PLANNING BOARD MEETING AGENDA

Re: 33 Astor Place
Monsey, NY, 10952
Tax Lots: 41.06-1-78

Re: Nancy Rubin, 33 Astor Place – Clearing, Filling or Excavation Permit
SBL# 41.06-1-78

Attn: Alicia Schultz, Deputy Village Clerk
Re: 33 Astor Place
Clearing/Filling/Excavation Application Review

S.B.L. 41.06-1-78
PLOT PLAN
FOR
33 ASTOR PLACE
VILLAGE OF WESLEY HILLS - ROCKLAND COUNTY - NEW YORK

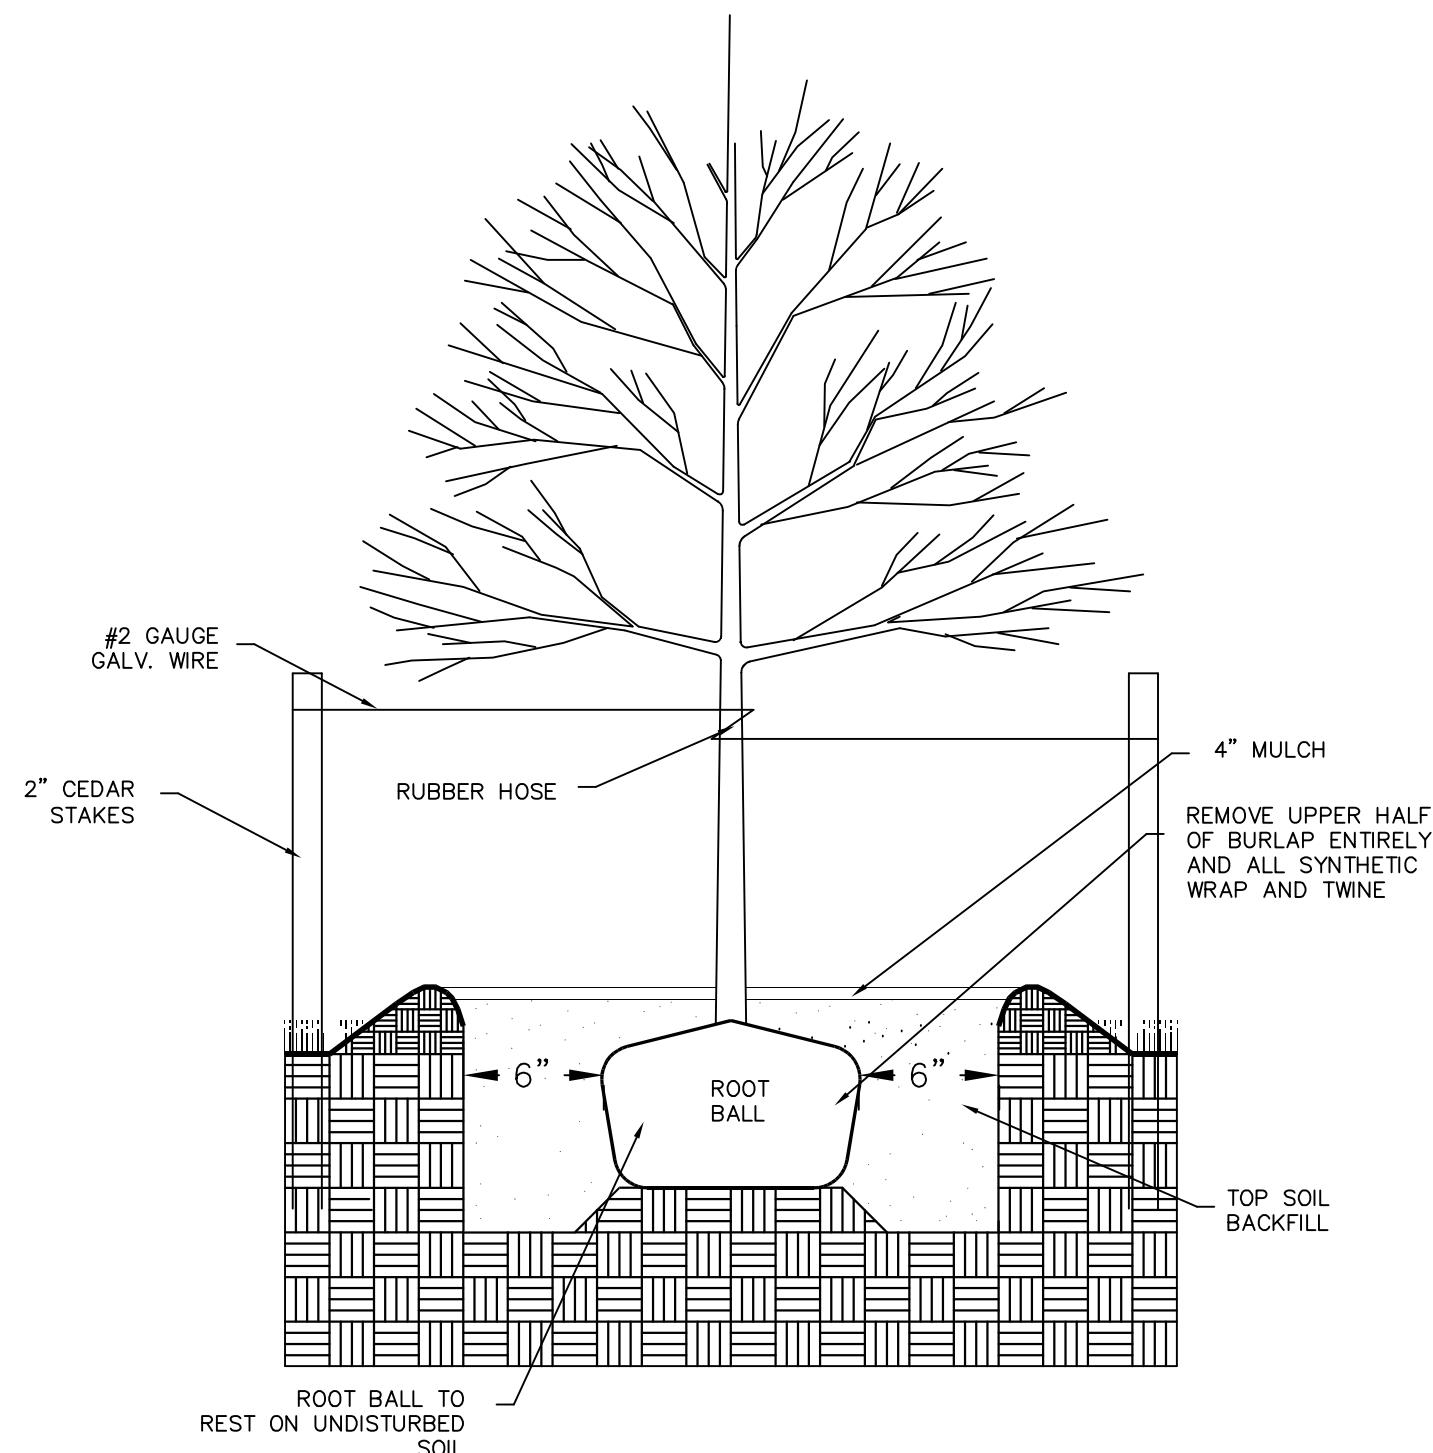
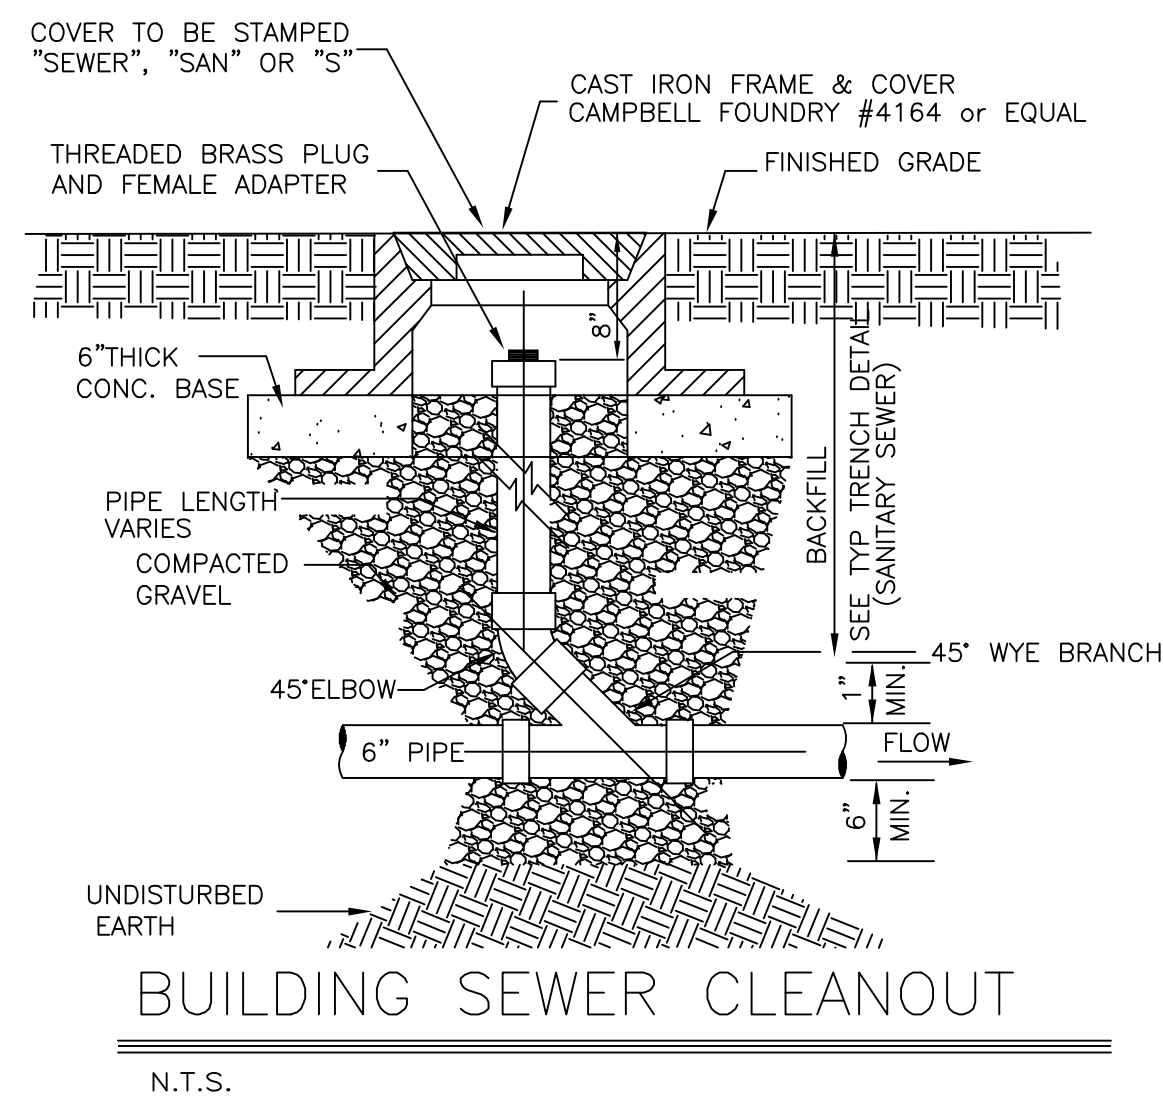
4. A standard detail for a Cambridge Sigma 8 wall has been provided. The detail does not indicate the proposed fence on top of the retaining wall as shown on the Civil Tec Plan. The discrepancy shall be resolved.
5. Pervious pavers are proposed in the rear yard; however, the previous response letter discussed high bedrock in the rear yard. Infiltration in fill is permitted, subject to minimum separation and testing requirements. Consideration as pervious area is not recommended if minimum requirements are not met. Applicant has responded that 'the pavers will all be fill so there will be

no separation issues with groundwater' This does not address insitu bedrock separation or insitu soil testing. We request the following criteria be provided as per NYS DEC guidance to be considered pervious:

- a. Insitu/natural soil layer below infiltration system has an infiltration rate greater than or equal to the 0.5 in/hr
- b. Ground water and bedrock levels in insitu/natural soil should be two to three feet below grade

- c. Fill material is an engineered fill that is tested after placement (by geotechnical firm) and demonstrated to be equivalent to a soil material acceptable for the installation of an infiltration system (i.e. infiltration rate greater than or equal to 0.5 inches /hr, etc.). Infiltration rate of fill material should be similar infiltration rate as insitu/existing soil.

- d. If there is a difference in the infiltration rates between the fill and insitu/native soil, the designer should use the more conservative (i.e. slower infiltration rate) when determining whether the infiltration system will dewater (exfiltrate) within the required 48 hours (see Section 6.3.2 "Conveyance" of the Design Manual).

- e. Required vertical separation distances to groundwater/bedrock are maintained
- f. Required horizontal separation distances to surface waters, wells, etc. are maintained

- g. There is adequate fill along the edges of the infiltration system to prevent seeps/breakouts
- h. As per guidance from the new draft NYS DEC Stormwater Management Design Manual, infiltration facilities proposed on naturally steep slopes require additional analysis. A slope stability / global stability analysis of the retaining wall shall be provided from a structural or geotechnical engineer.

This remains to be addressed – soil test results to be submitted

4. The structural engineer has now provided specific wall details. The fence has been moved 1' behind the wall.
5. The area with pavers will all be on fill so there will be no separation issues with groundwater or bedrock. The fill will be anywhere from 4' to 14' above existing grade. A note has been added that the fill under the pervious pavers must be at least 1" per hour to meet the design specifications. A percolation test done in the front yard in 2022 found bedrock at 5' with no signs of bedrock and a second location had no signs of bedrock or groundwater to a depth of 9'. I have attached the test results from 2022 now for reference.

In addition, we have added photographs of the type of wall that will be constructed. The fence was moved off of the wall and will be behind the wall. It will be a chainlink fence. The

landscape architect's plan shows landscaping to go with the fence for screening. The fence is now called to be 4' high.

SCREEN PLANTING PLAN

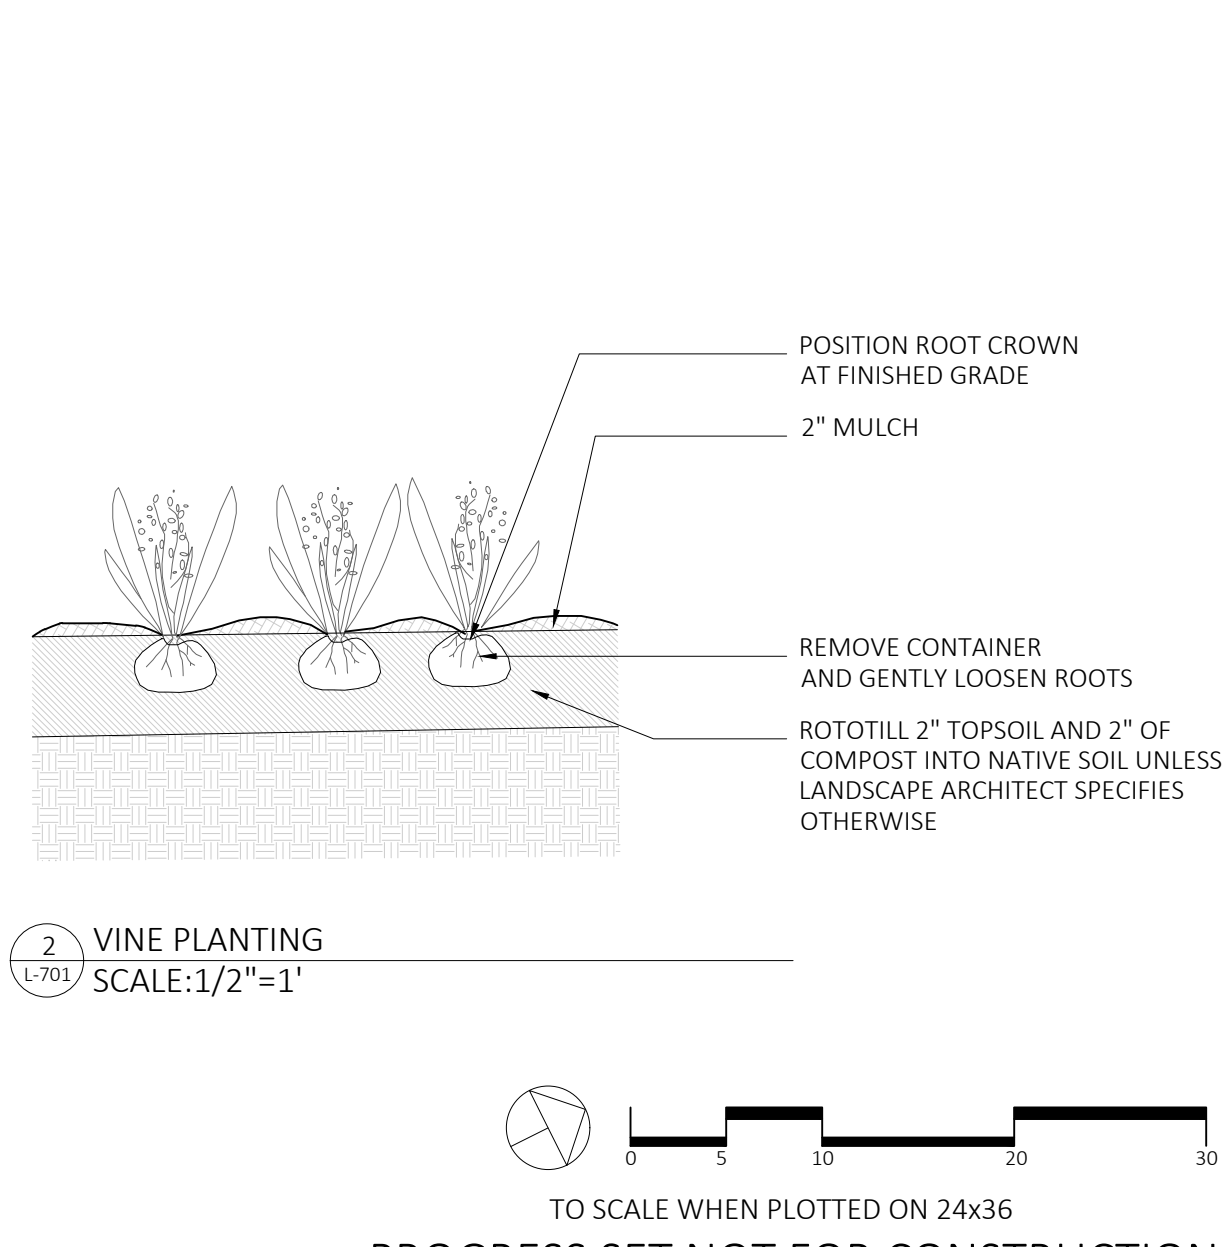
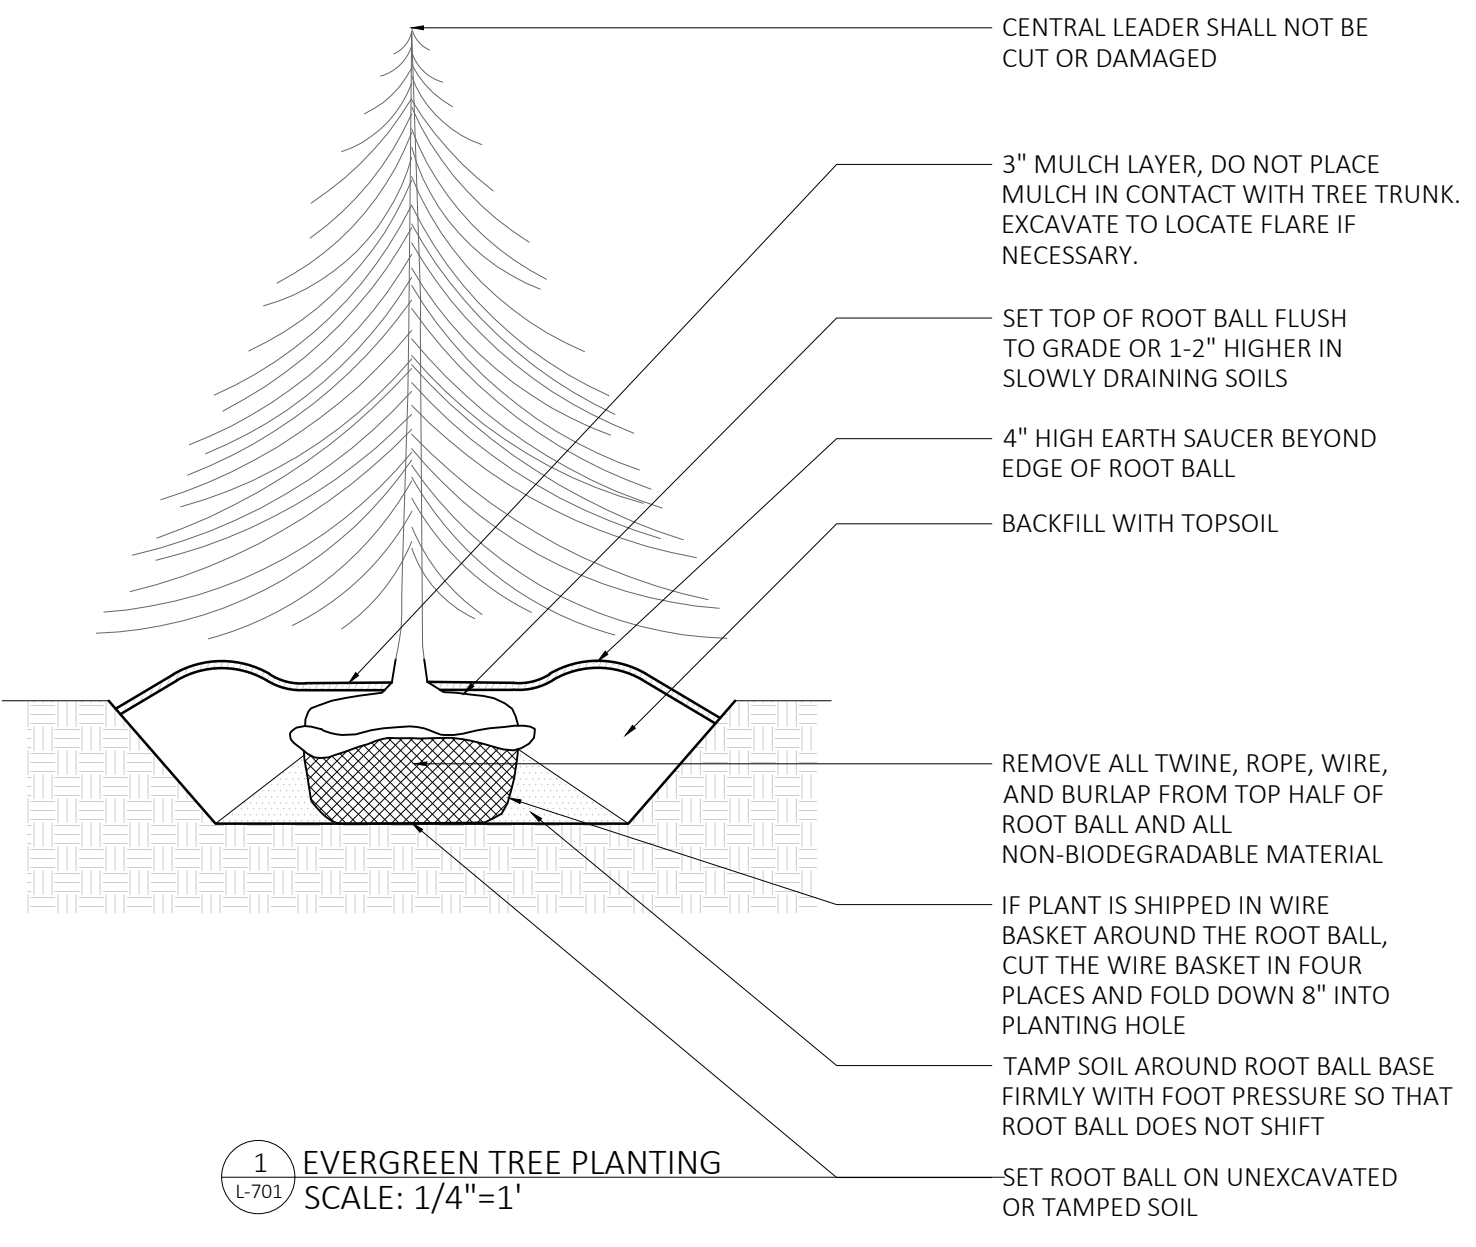
2. We note that fencing is being proposed at the tops of the retaining walls, and landscaping is only proposed at the bottom of the walls. Please consider a more aesthetic choice for fencing other than 2" wire chain link that is specified in the Gdanski plan. Also, please consider adding some plantings at the top of each wall to soften the look of the fencing, as viewed from neighboring properties.

3. We approve of the Thuya Green Giant trees specified at the bottom of the walls, as well as the Hedia Helix shrubs and Picea trees. The proposed ivy will help mitigate the views of the wall materials. We will defer to the Village Engineer regarding the wall construction specifications.

SCREEN PLANTING PLAN

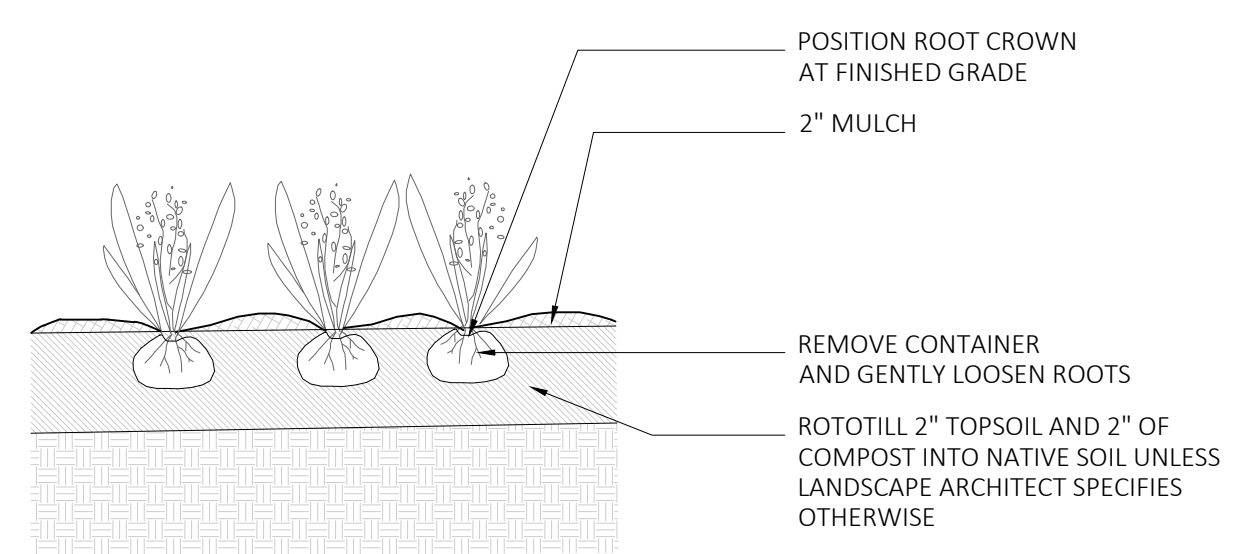
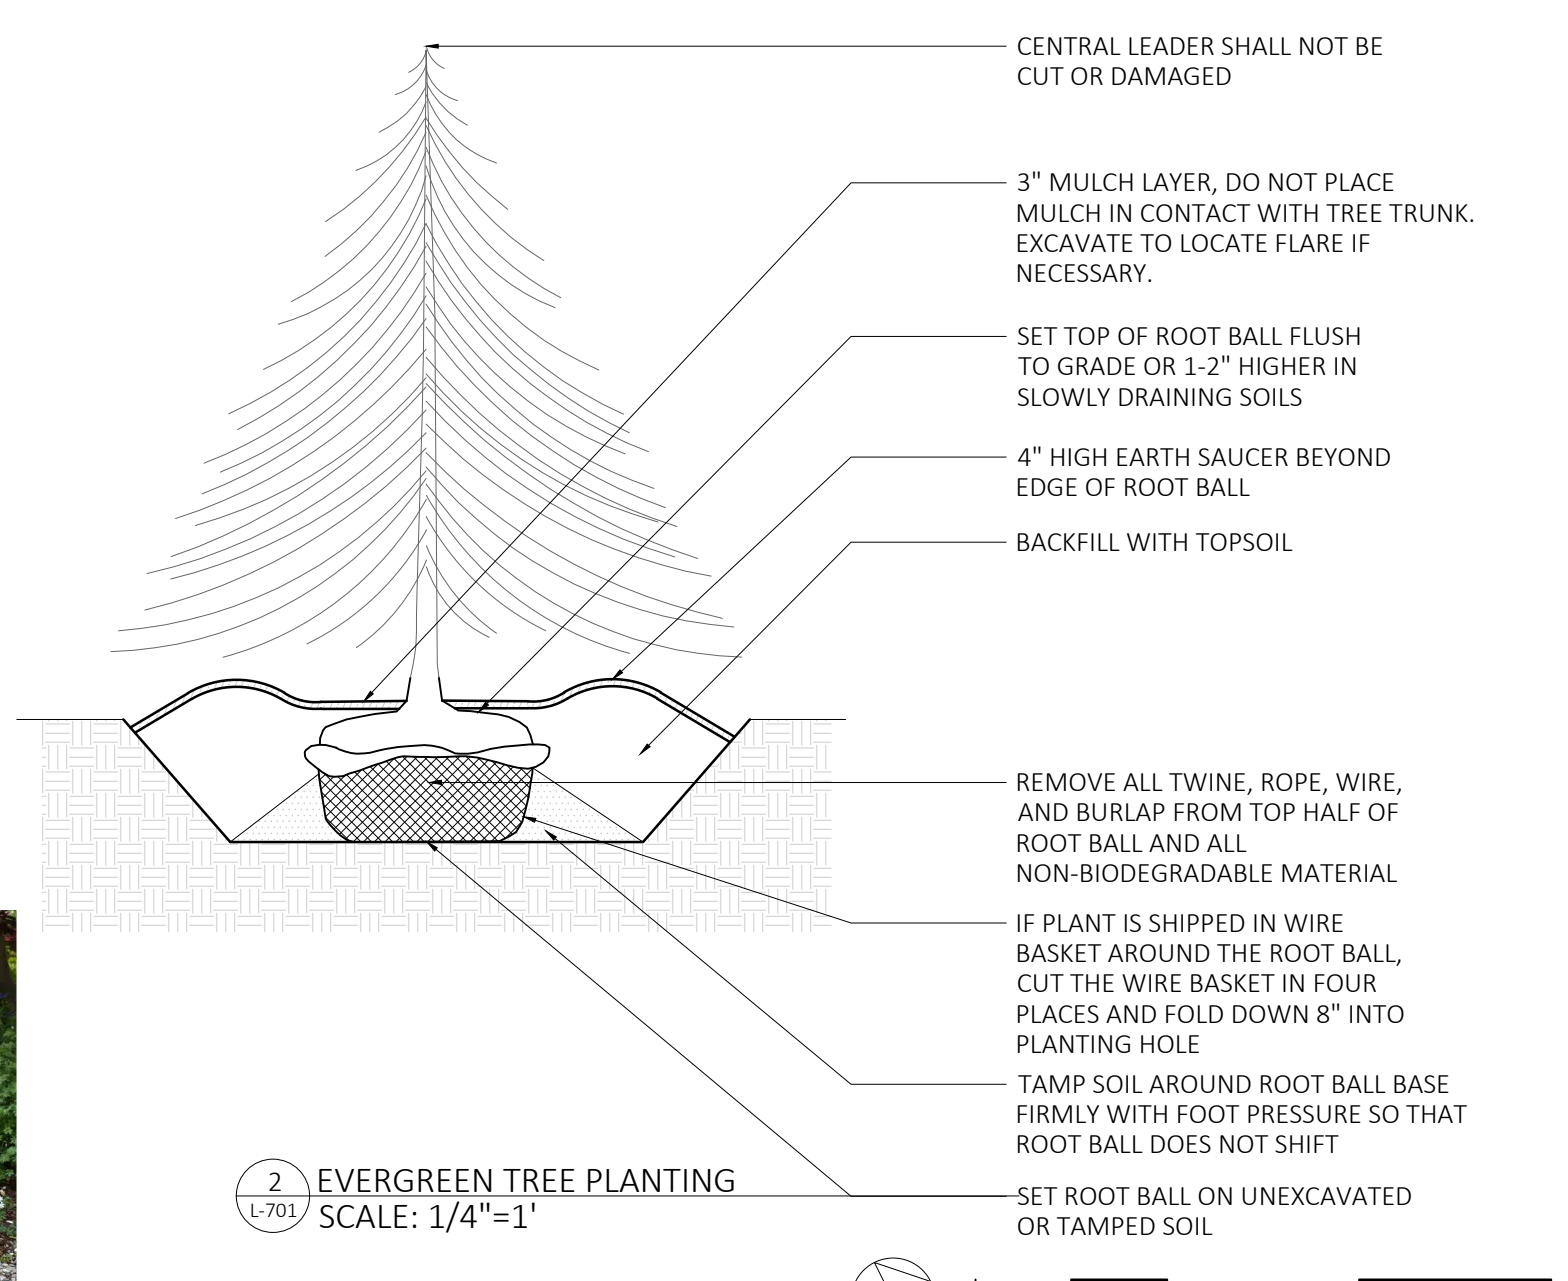
2. In response to comment #2 of our prior memorandum, in the new wall construction plan set by Skrable, the applicant has removed the wire fence detail. (A wire fence had been specified and shown on the previously submitted wall construction plan by Gdanski.) The newest landscape plan by Yost shows fencing and has added plantings at the top and bottom of each wall to soften the look of the fencing.

The specified plantings on the Yost Landscaping Plan comply with our previous memorandum comment although it is unclear what type of fence the applicant is going to install instead of the 2' mesh wire fabric fence specified in November. **Please provide the specifications of the fencing which is shown on the landscaping plan.** We will defer to the Village Engineer regarding the wall construction specifications.
